PLANNING, ZONING, & BUILDING DEPARTMENT  
PZ&B Staff Memorandum: Landmarks Preservation Commission

SUBJECT: COA-23-050 101 FOUR ARTS PLAZA, The Philip Hulitar Sculpture Garden

MEETING: JANUARY 17, 2024

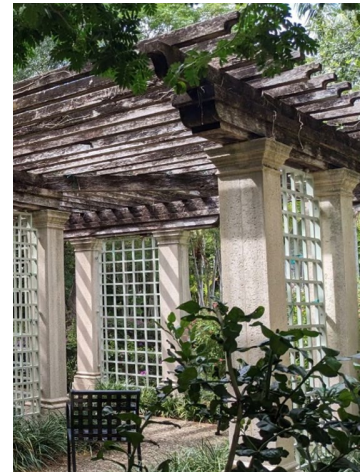
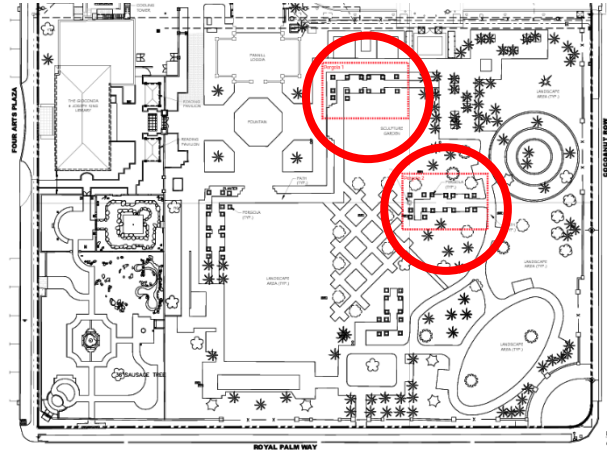
- Replace existing wood rafters and beams on two (2) pergola structures in the garden with a painted Azek product.

While the scope of work includes a material changes to non-historic elements of the garden; it is still advisable to utilize authentic materials that can patina with age over synthetic materials that may have too glossy or smooth of a finish than the wood they are attempting to simulate.
